Planning Commission
Staff Report
ADDENDUM

MEETING DATE: **SEPTEMBER 4, 2019**

SUBJECT: **Z19-10: BELROSE - REQUEST TO AMEND ORDINANCE NO. 2659 TO AMEND THE CONDITIONS OF DEVELOPMENT WITHIN THE SWC OF GREENFIELD AND CHANDLER HEIGHTS PLANNED AREA DEVELOPMENT (PAD) ZONING DISTRICT FOR APPROX. 82 ACRES OF SINGLE FAMILY-6 (SF-6) ZONING DISTRICT, LOCATED AT THE SOUTHWEST CORNER OF GREENFIELD RD. AND CHANDLER HEIGHTS RD.**

DEVELOPMENT PLAN EXHIBIT

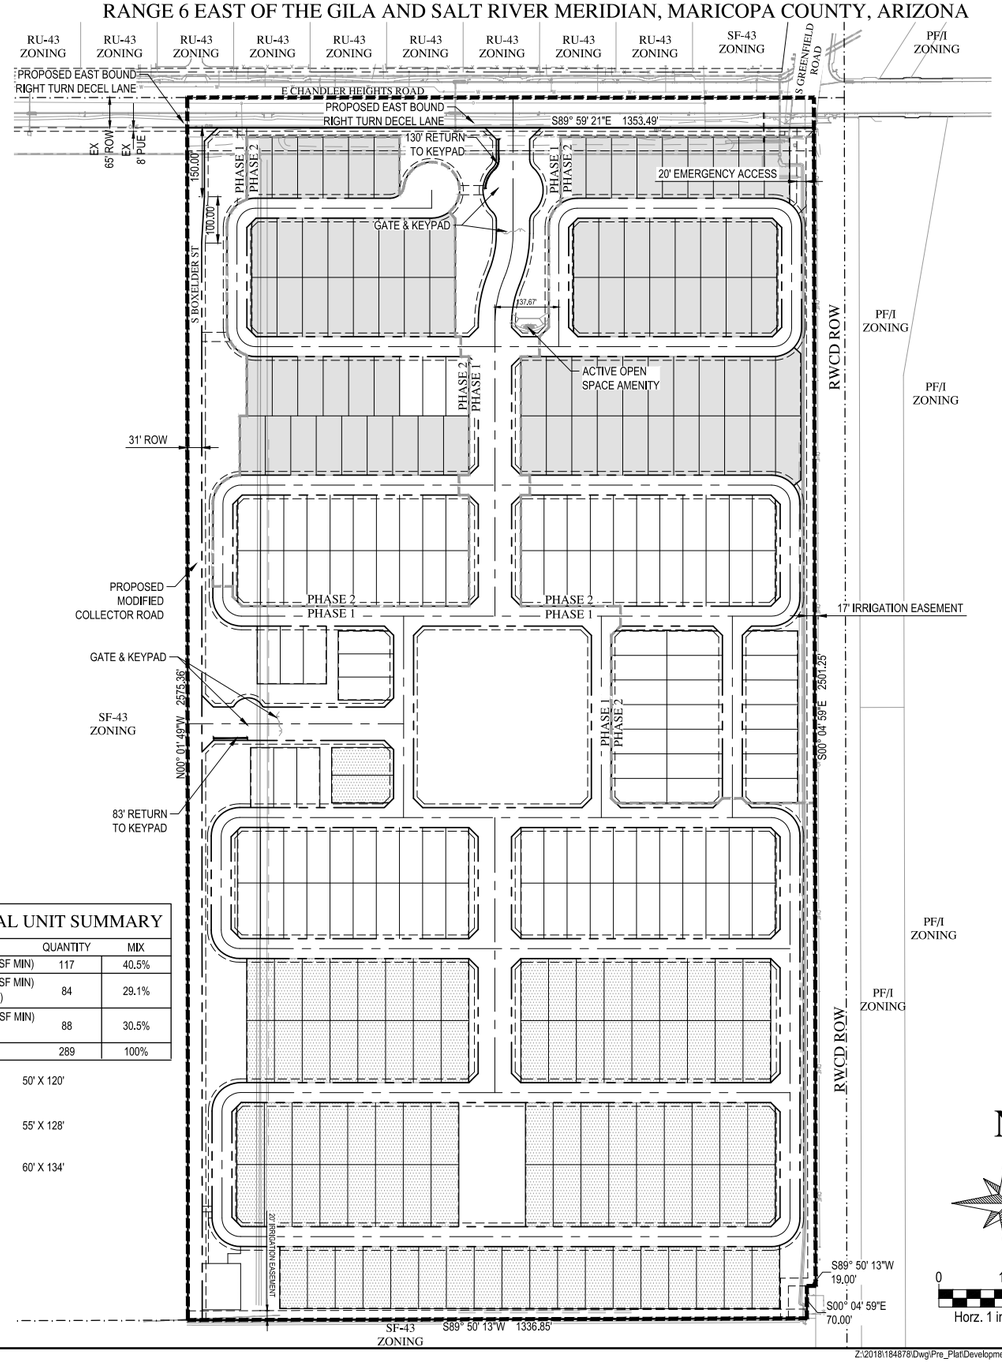
As proposed, the local private street cross-section shows a 33-foot back-of-curb to back-of-curb

The Planning Commission was generally supportive of the proposed development; however, was concerned with the total number of proposed deviations and more specifically had concerns with reducing the width of front porches from 6' to 4', reducing or eliminating the 20' landscape setback along Chandler Heights Rd., reducing the side yard setbacks to 5' and eliminating the stagger of homes along the front lot line.

- Stagger: modified to only exclude Plan 3502 ~~10%~~ of the 50' wide lots. ~~which results in 12 lots~~.
- Minimum front porch depth: A majority of porches will have a minimum 6' depth; however, due to the anticipated product design, the applicant requests a slight reduction to a minimum 5' 4" depth, as measured from the dwelling façade to the exterior edge of the supporting post or wall~~, to accommodate approx. 7% of all plans in development~~.

Upon analyzing the requests, Staff is in support of the proposed deviations as listed in the table above. Please note that Staff is in support of the modified deviations to eliminate the stagger requirement on Plan 3502 ~~10% (12 lots)~~ of the 50' wide lots because the anticipated housing product allows for a varied street scene with houses at different setbacks. Staff is also in support of the slightly reduced front porch width from 6' to 5'-4" as there will still be plenty of useable space in-between the columns. Staff will be recommending during the standard plans review that

no railings be provided on the front elevations for Plan 3502 to maintain as much useable space as possible.
